# ***SERVICE PROCEDURE***

**15514  
JULY 2015**

**SUBJECT: SAFETY RECALL**  
**Engine Intake Grid Heater Power Supply Cable on certain DuraStar<sup>®</sup> and WorkStar<sup>®</sup> model trucks and HC Commercial Bus models built 13 May 2009 thru 24 June 2013 with EPA 2010 emissions engines**

**Figure 1. Intake Grid Heater Harness Interference.**

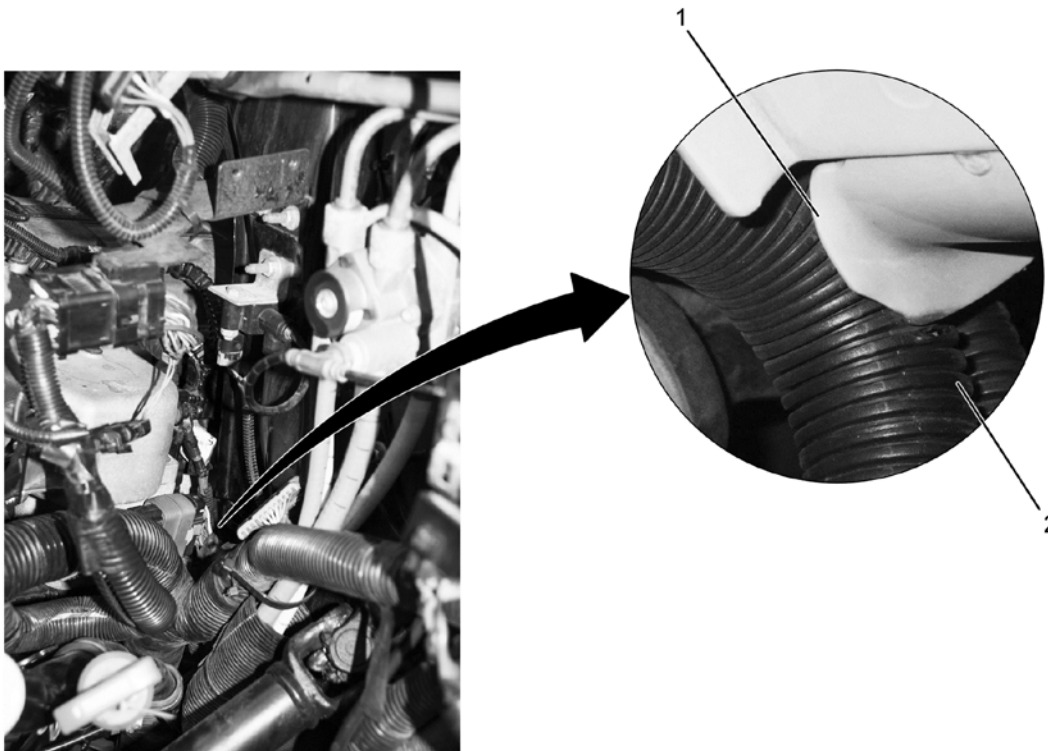
The engine intake grid heater power feed cable may have been improperly routed resulting in contact with a sharp metal edge on the cab which could lead to possible chafing of the wire insulation and cause an intermittent electrical short. An intermittent electrical short may cause a vehicle fire possibly resulting in property damage or personal injury.

5. Inspect intake grid heater harness (Figure 1, Item 2) for interference with cab body (Figure 1, Item 1) and any possible damage to the wire insulation.

**NOTE:** If insulation is rubbed through to copper, perform wire repair. Refer to **IK0800269** for proper wire repair procedure.
